DESIGN RECOMMENDATION MEETING

2016 23rd Ave S Seattle, WA

SDCI PROJECT NO.:
3024101

MEETING DATE:
June 27, 2017

Figure 1: Floor plan comparison between EDG and current design, which was revised per board recommendation. Larger permanent apartment units are now located along S Hill St.

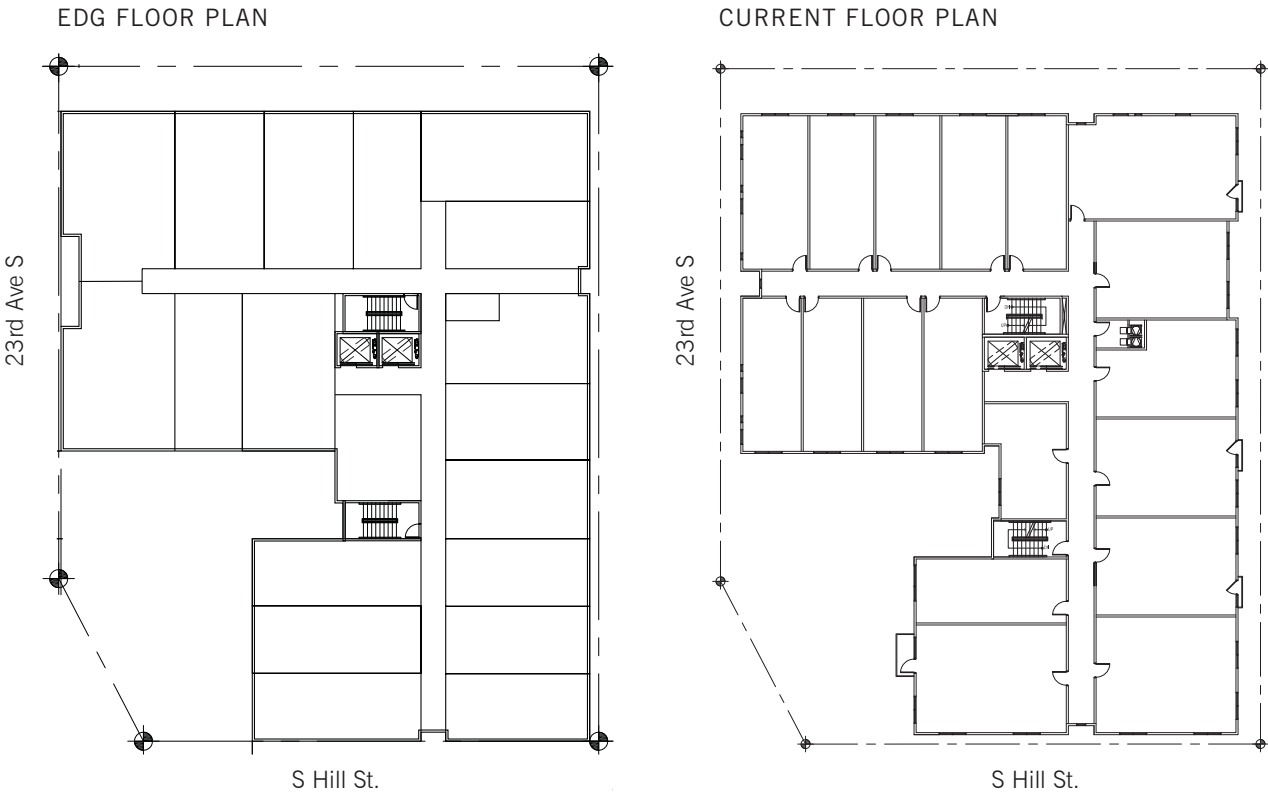
3b	<p>The Board discussed how locating the units for the more permanent residents along S. Hill Street would allow for more public engagement and provide better views to Mt. Rainier. (DC1-A, PL2-B-1)</p>	<p>Units for more permanent residents are now locating along S Hill St, which is a quieter street. With the SDOT plan of closing S Hill St being canceled, these units are now facing the plaza area where more public and pedestrian activities are anticipated.</p>	<p>See Level 2-6 Floor Plans (pg. 21-23) and Figure 1 (pg. 16)</p>

Figure 2: Diagram showing design evolution

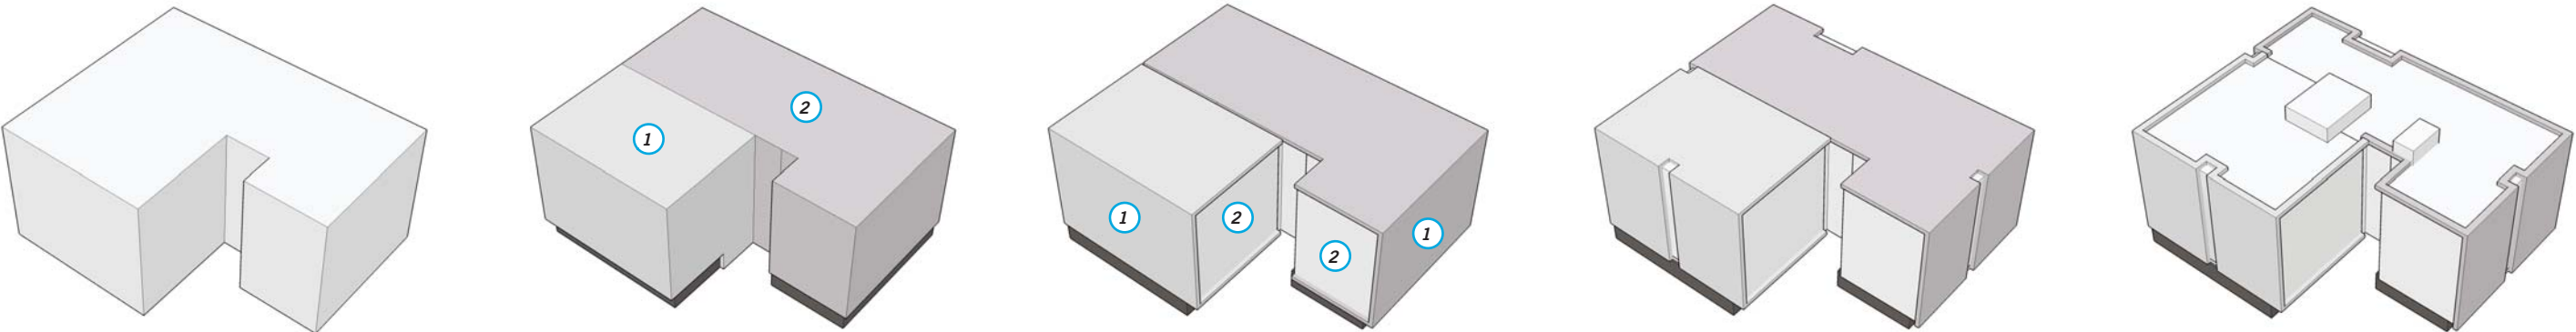
BOARD COMMENT		DESIGN TEAM RESPONSE	REFERENCE
1a	<p>Massing and Articulation</p> <p>The Board focused their discussions on the applicant's preferred scheme, Option 3, which proposed two large interlocking massing elements with an entry plaza to serve as public open space. The two masses are comprised of apartments and short term stay units. The Board unanimously directed the applicant to proceed forward with the preferred Option 3 with the condition that the massing treatment shown continue along the north and east façades. The Board also noted that they expect to see all elevations included with any future submittals. (DC2-A-2, DC2-D-1, DC2-C-3)</p> <p>The Board supported the two volumetric elements which represented the two types of units identified in the proposal.</p>	<p>Noted.</p>	<p>See Colored Elevations (pg. 26-29 and pg. 40) and Renderings (pg. 31-33)</p>
1b	<p>The Board noted that there needs to be consistency between the two massing elements, especially in the relationship between the ground and upper floors, and that the use of articulation in the upper floors can be used to break up the overall massing volumes.</p>	<ul style="list-style-type: none">• The design intent is to have two different treatments for short-term stay housing and regular apartments, while having the ‘shared’ elements that tie the two masses together so they don’t look like two separate buildings.• At each mass, and where the two masses connect, the composite wood siding plane, ‘a hinge or a break,’ is introduced to help break up the perceived mass.• Playful facade with more random window pattern is utilized at short-term housing mass, while more orderly fenestration, with balconies and Juliet balconies, are utilized at regular-apartment mass.• The shared elements are the ‘frame’ that wraps around each mass, as well as the composite wood panel that is used as part of window module. The rhythm of balconies and Juliet balconies at the regular-apartment mass also reflects the window pattern rhythm used on short-term housing facade.• Commercial space at short-term housing mass is fully glazed. Its simplicity contrasts to, and doesn’t compete with, the playful facade above. Commercial space at regular-apartment mass projects warmer atmosphere, with manufactured stone veneer clad columns, and recessed dark-color storefront windows, reflecting the homelike treatment of the facade above.	<p>See Diagrams (pg. 17), Colored Elevations (pg. 26-29 and pg. 40) and Renderings (pg. 31-35)</p>

LEVEL 1

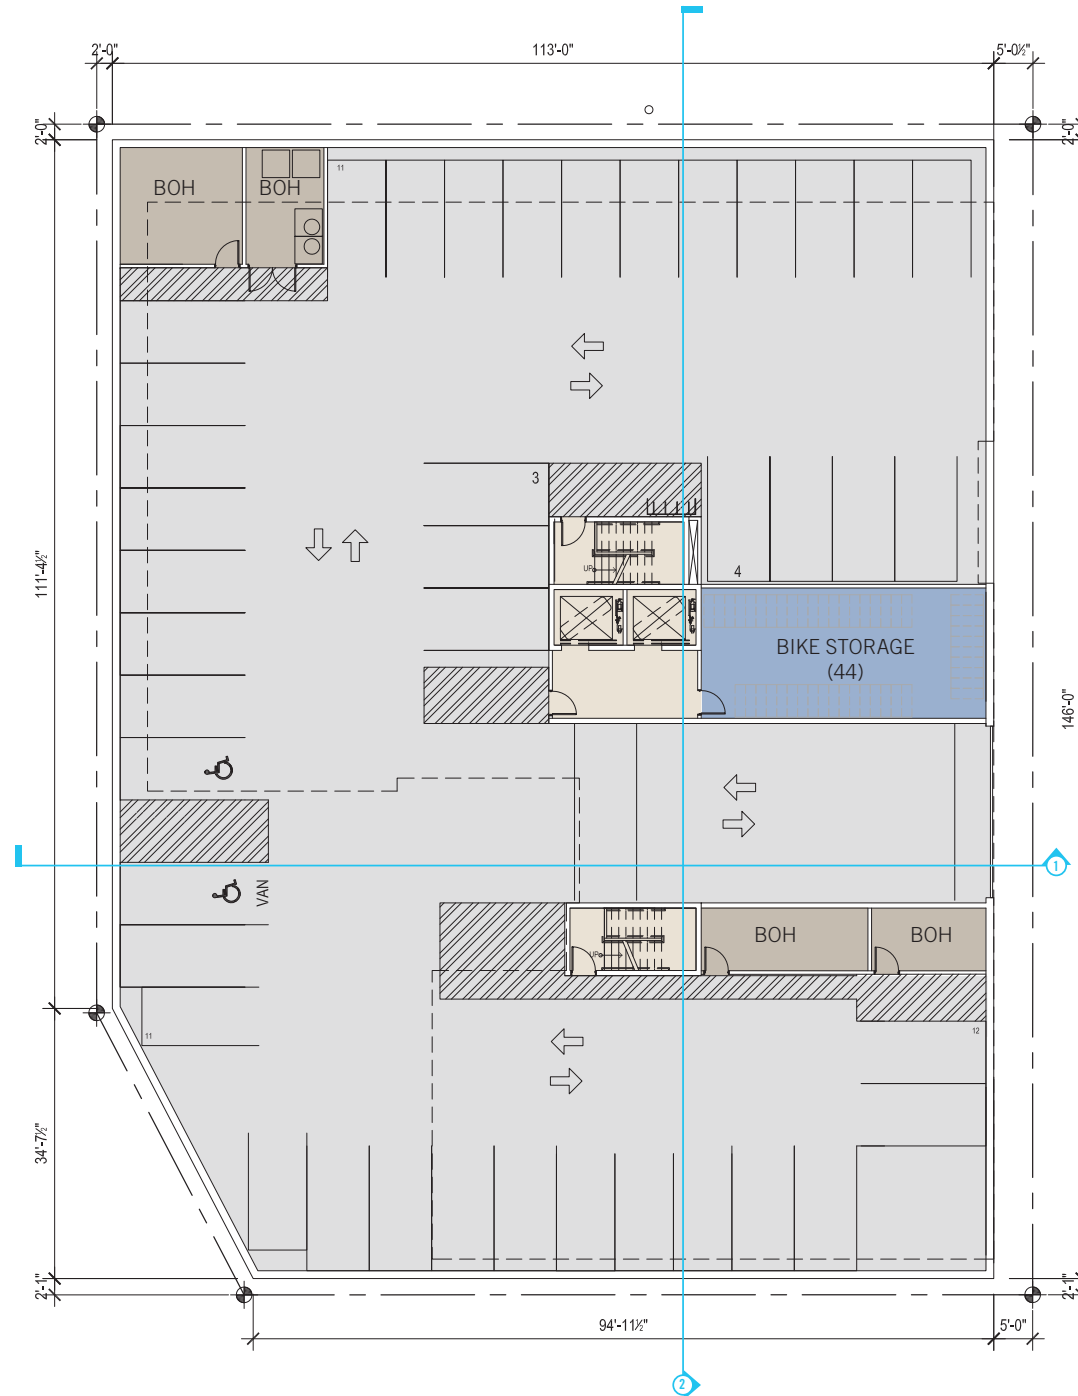
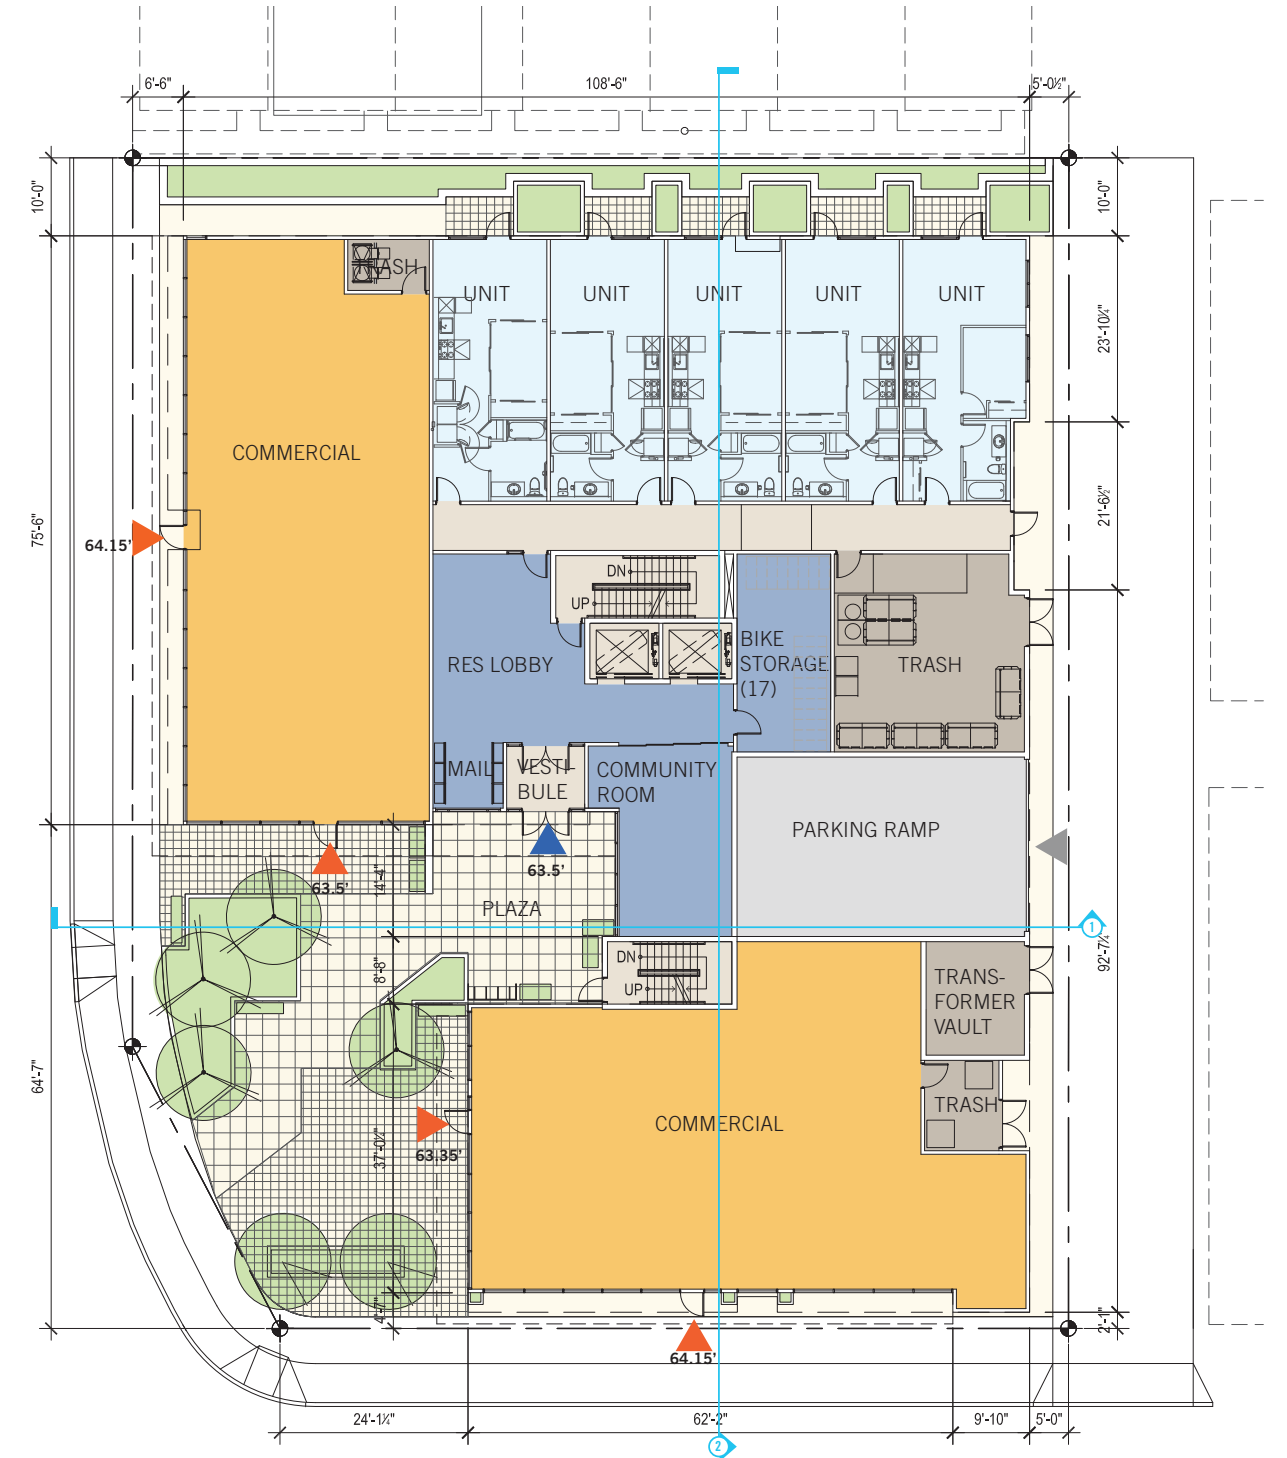
3a	<p>Interior Layout of Spaces</p> <p>The Board discussed the current plan configuration of preferred Option 3 and expressed concerns over the layout of the interior spaces, location of the primary entries, and lack of architectural wayfinding elements. The Board agreed that developing legible entrances should be a priority moving forward. (PL2-D-1)</p> <p>The design of the primary entry and main focal point of the preferred scheme was discussed in detail as the Board did not support the proposed location of the bike storage area and secondary staircase. The Board strongly suggested a redesign of this area to place more emphasis on the residential lobby and entry. (PL3-A-1)</p>	<p>The residential lobby area has been modified per board’s recommendations. The bike storage has been relocated. The entry area consists of spacious lobby and mail area, as well as an adjacent community room. Ample glazing is provided in this area, strengthening the entry corner with high level of transparency. The entry ‘frame’ as well as signage are utilized so the entry is easily and visually identifiable. The entry is also emphasized by the vertical expression of the facade at this corner, with the use of composite wood siding. Landscape design also helps with the way finding.</p>	<p>See Rendering (pg. 34), Landscape Plan (pg. 24), Site Plan (pg. 14) and Ground Floor Plan (pg. 20)</p>

TYPICAL FLOORS, OPTION 1

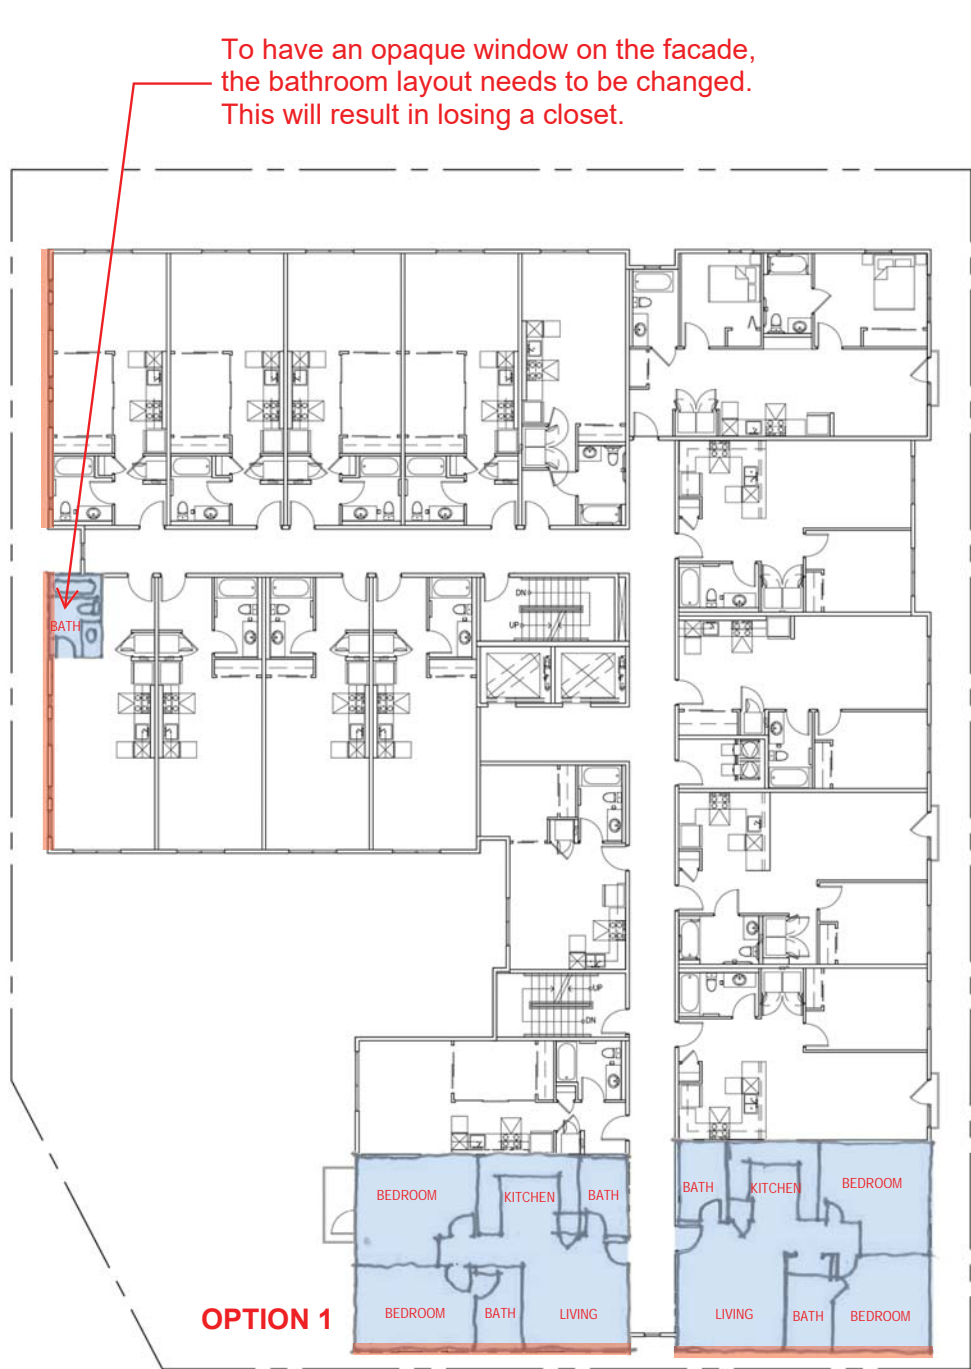
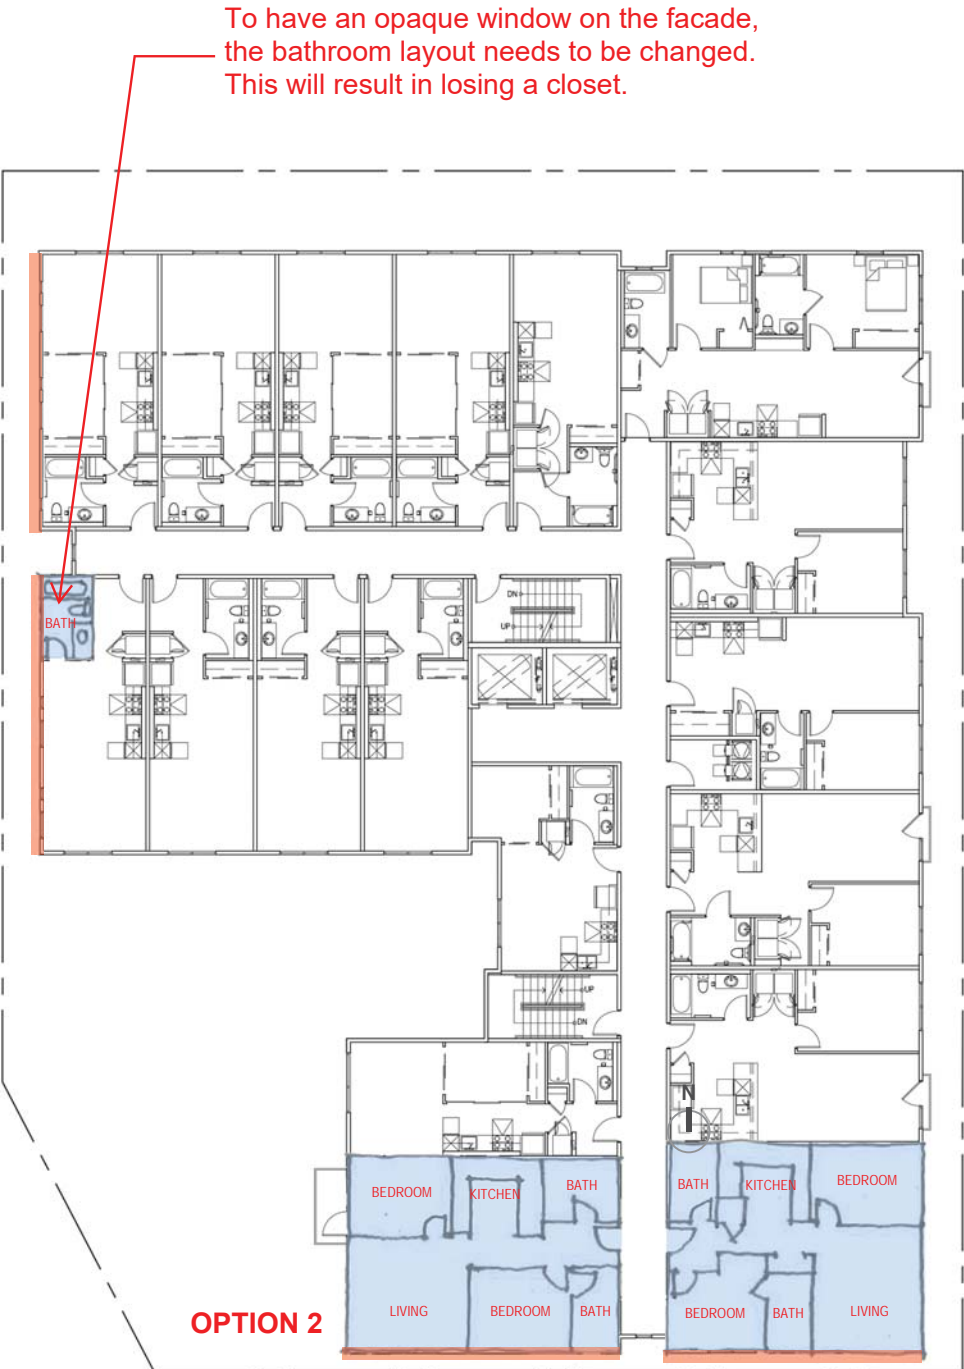
The study of alternative unit plans has been done as a response to correction item # 1 - to create more transparency on these two facades (highlighted here).

The design team thinks that this unit alternative is not as good a solution as an original unit plan. The kitchen doesn't connect well with the living space. The unit as a whole feels less open.

The design team thinks that this unit alternative is not as good a solution as an original unit plan. The kitchen doesn't connect well with the living space. The unit as a whole feels less open.
